# **PRODUCT CHANGE NOTICE**

## **Part Marking Configuration Change for Intersil TDFN, uTDFN, and uTQFN Packaged Products**

**Refer to:  
PA10114**

**Date: November 10, 2010**

### POD 1.2 x 1.0 - Single Digit Part Code

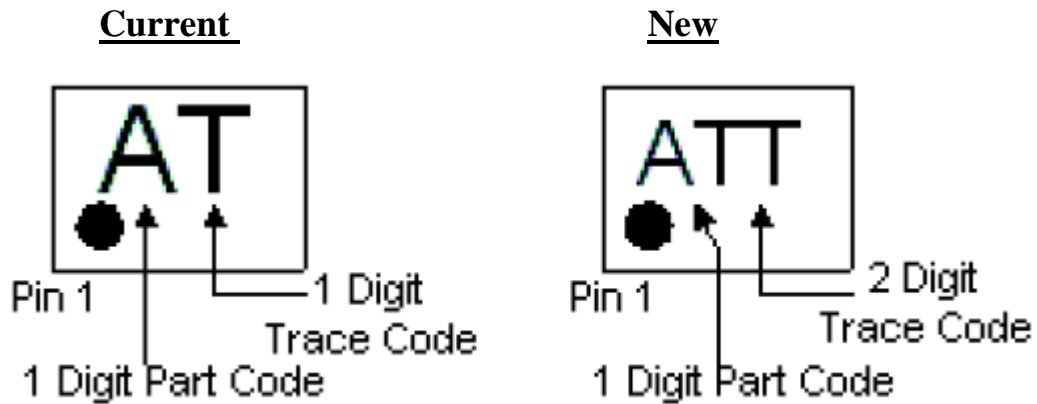
This notice is to inform you that Intersil is changing the configuration of the “top side” marking (brand) for the listed TDFN (Thin Dual Flat No-lead), uTDFN (Ultra Thin Dual Flat No-lead), and uTQFN (Ultra Thin Quad Flat No-lead) plastic packaged products. The restructured layout allows for the marking of additional characters in support of enhancing product traceability. There will be no change to the product code that is currently marked on the device. Examples of the current and new marking configurations are included for reference.
